3 1 This Resolution including attached Exhibit A, constitutes the Agency s
4 official comments on the Final EIS/EIR that was prepared for the proposed Mid-City
5 Exposition Light Rail Transit Project

CULVER CITY REDEVELOPMENT AGENCY RESOLUTION NO 2005- RA____

FINAL EIR/EIS (the "FEIR") COMMENTS MID-CITY/EXPOSITION LIGHT RAIL TRANSIT PROJECT November 21, 2005

Option 1 Maximized Parking

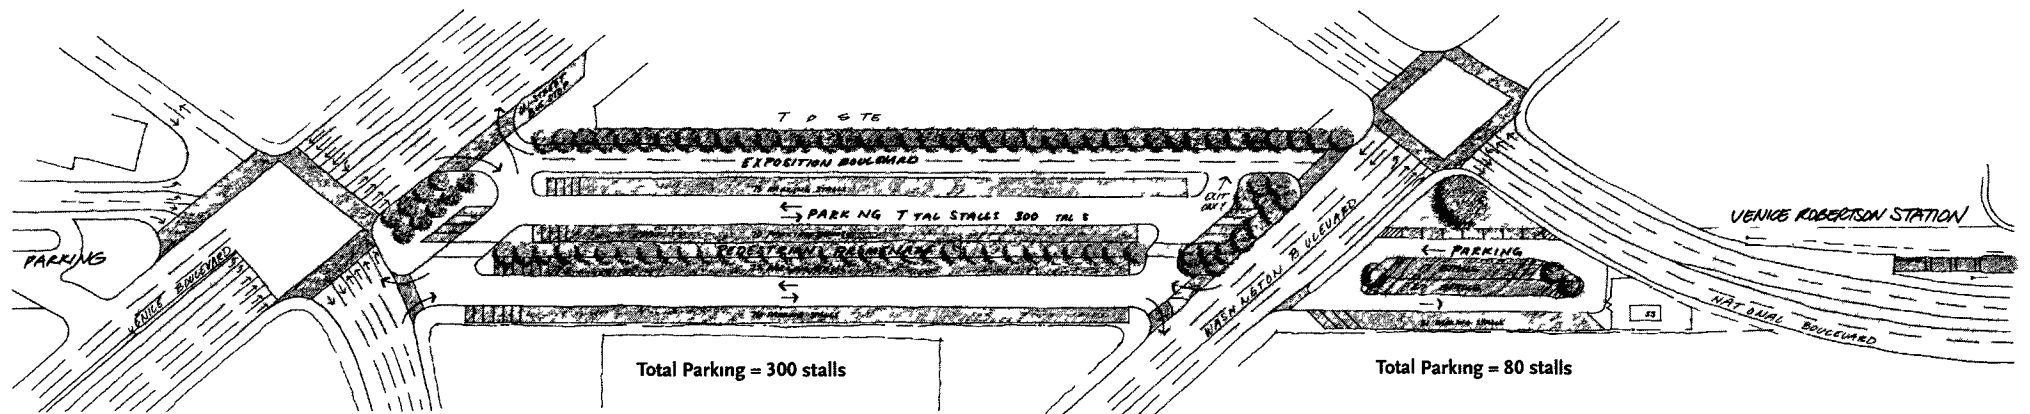
45 degree parking = 430 total stalls in 2 lots between Venice and National
